# Technical Memorandum

**Subject:** Grey Cloud Slough Restoration Third Party Review Response

**Date:** May 10, 2016

**Project:** 4876-032

Figure 1: Median Summer Flow Sensitivity Analysis

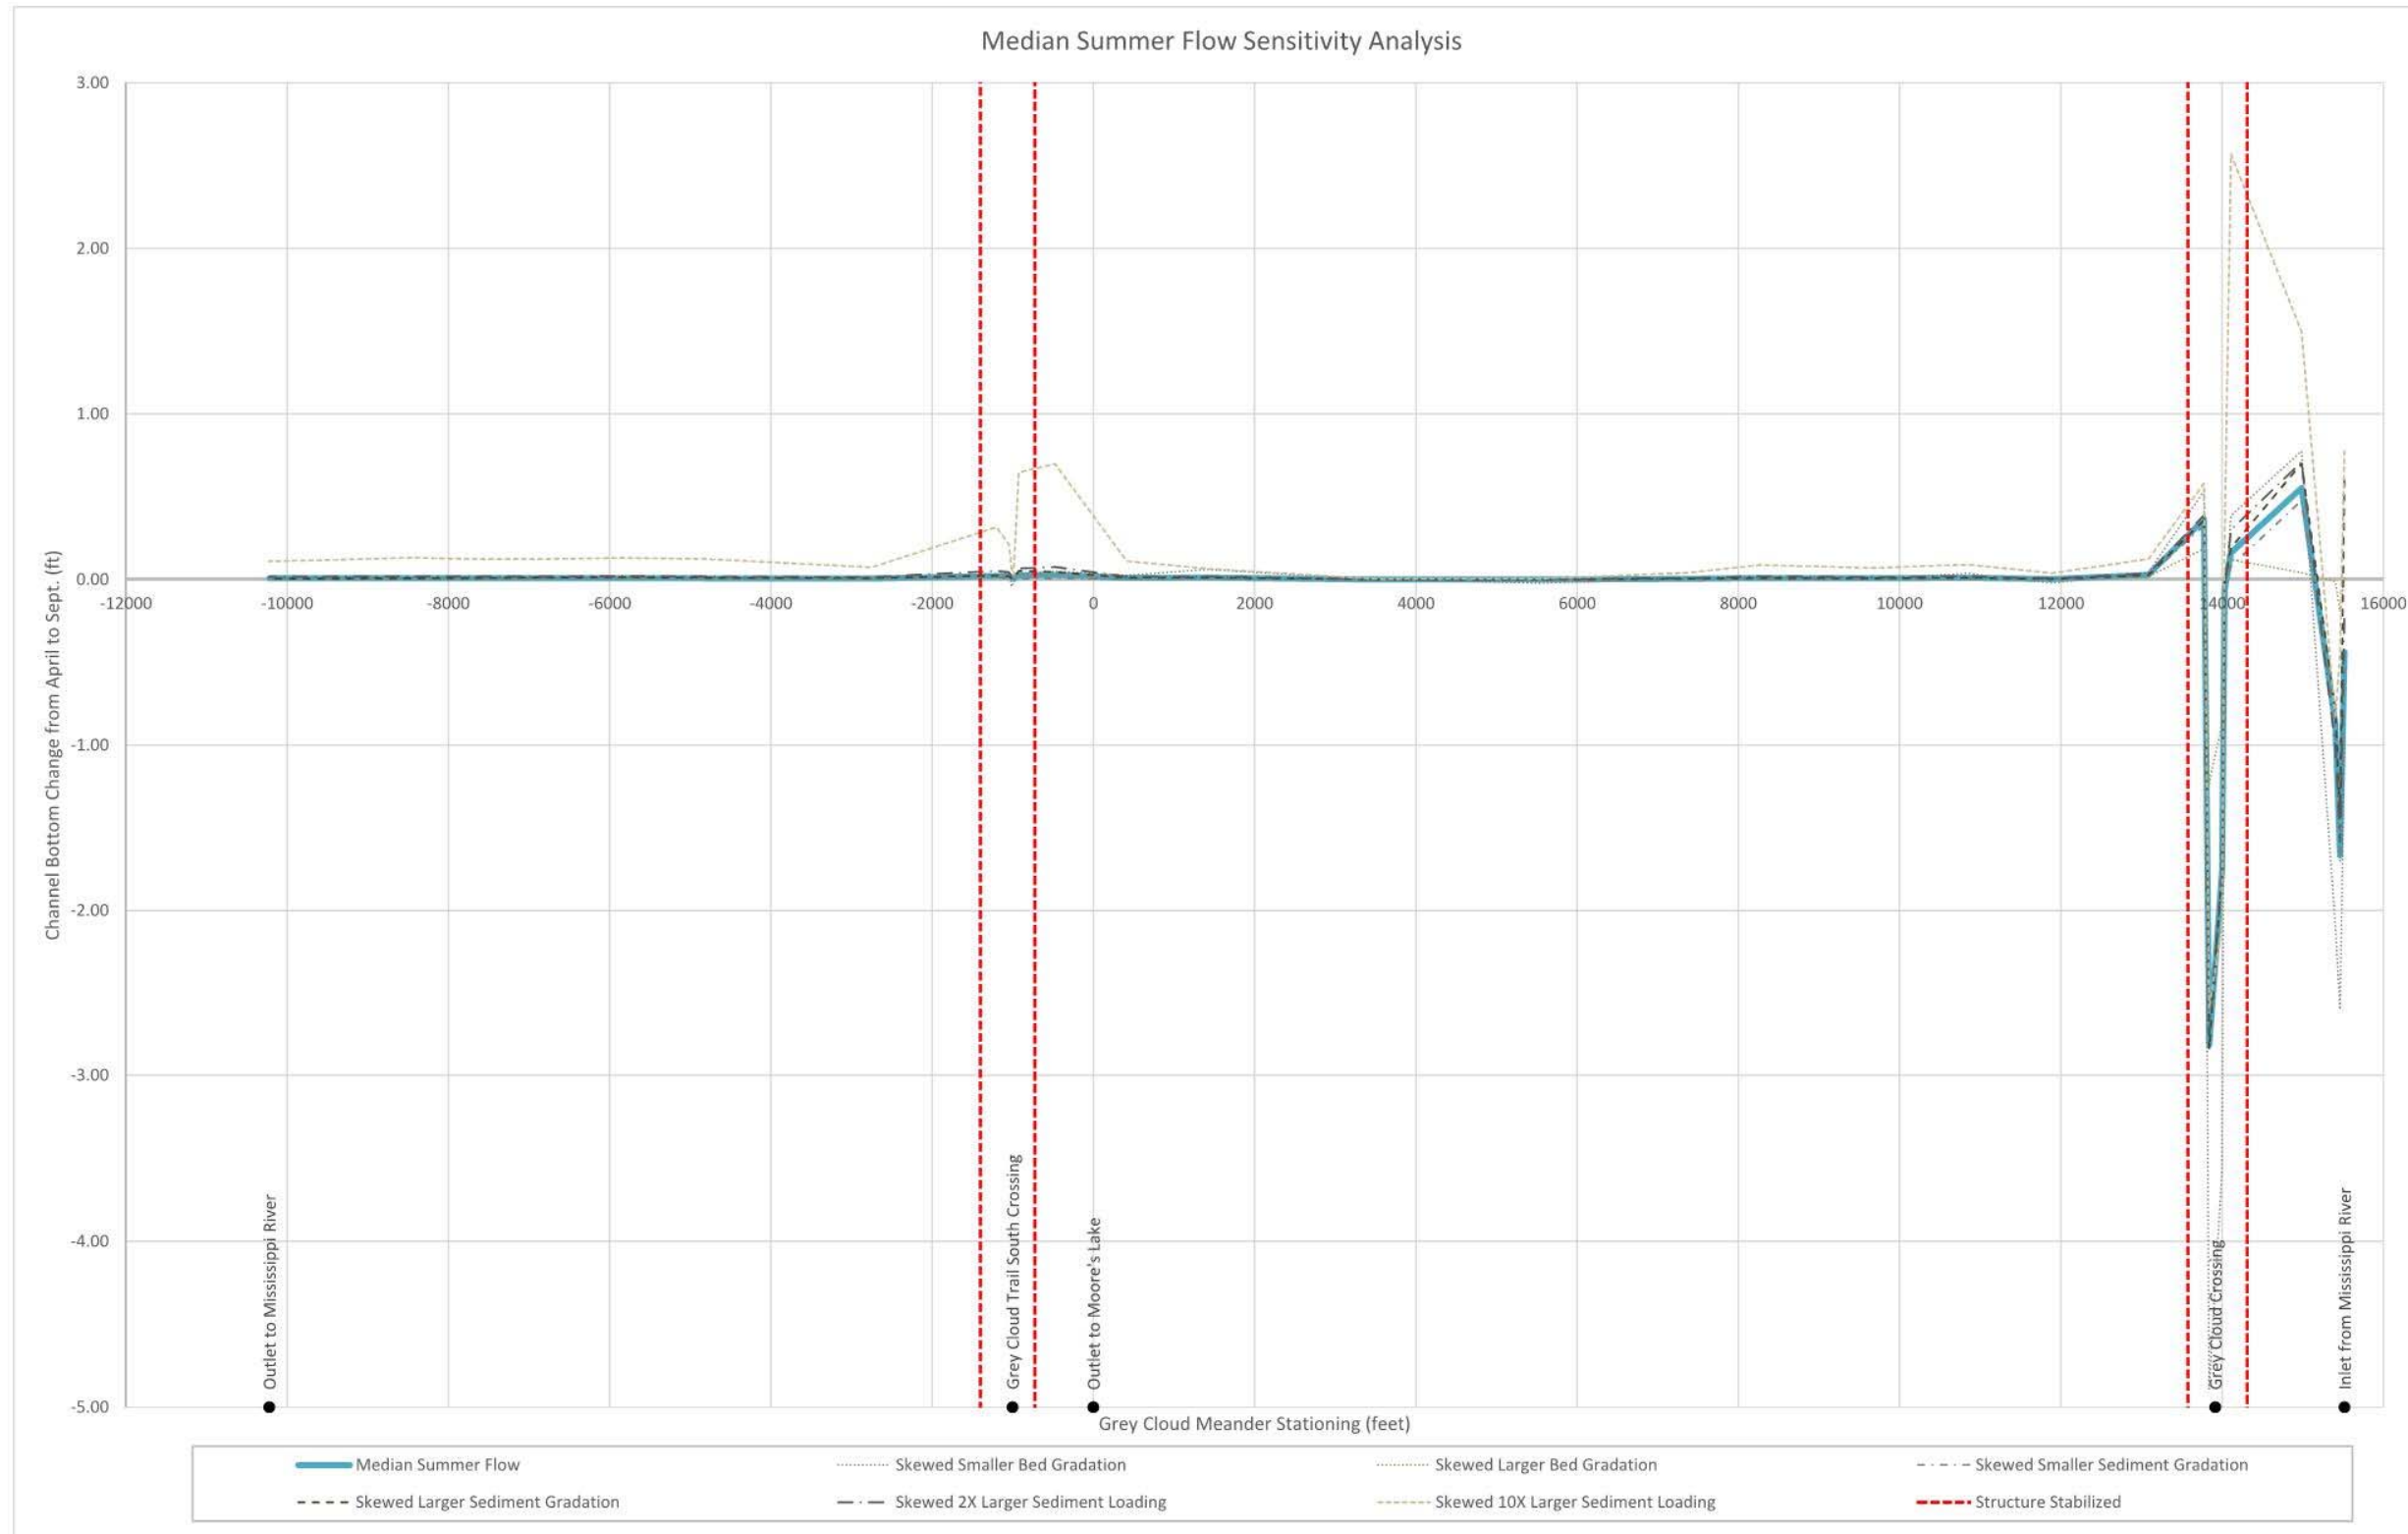
1. *Incorporate the wide flow areas along the downstream half of GCS into the model or provide discussion to justify their omission.*
2. *At a minimum, add a 2-year flood event analysis to represent geomorphic channel forming conditions. Ideally, complete a long-term sediment transport simulation of GCS.*
3. *Sample bed sediment for use in the model or conduct a sensitivity analysis with larger and smaller sediment to evaluate influence on results.*

4. *Conduct a sensitivity analysis in the model using a range of suspended sediment sources and an equilibrium sediment load based on bed material to evaluate influence on results.*
5. *Consider layering a rapid assessment of existing bank stability onto the scour and deposition results to estimate level or risk of bank erosion and channel migration if lateral migration is a concern.*

The results of the sensitivity analysis for the median summer discharge and 100-year discharge for 30-day duration are shown in **Table 4** and **5** respectively. **Figure 1 and 2** show the change in bottom channel elevation for all sensitivity analysis for the median summer flow and 100-year discharge respectively. The results shown using the base assumptions are similar to those shown in the feasibility report. There is some local scour around the structures which will be stabilized, and the remaining portions of the channel show no concerning scour or deposition.

The sensitivity analysis showed very little impact to the results due to changes in bed or sediment gradation. Under the assumption that GCS received 10 times the calculated sediment loading, the model showed a large impact to downstream sediment accumulation. Under this assumption 355,590 tons of sediment are delivered to GCS, which is 45% of the calculated load in the Mississippi River. Given all the known data, this is an extremely unlikely scenario that was modeled to gain perspective. Even within this nearly impossible event, at most 1.33 feet of sediment accumulated in Moore's Lake and GCS. Under base assumptions, this same location resulted in only 0.05 feet of accumulation. A more realistic skew in sediment load is the twice calculated load analysis. Even this showed at most 0.33 feet of accumulation in GCS during the 100-year, compared to 0.28 under base assumptions.
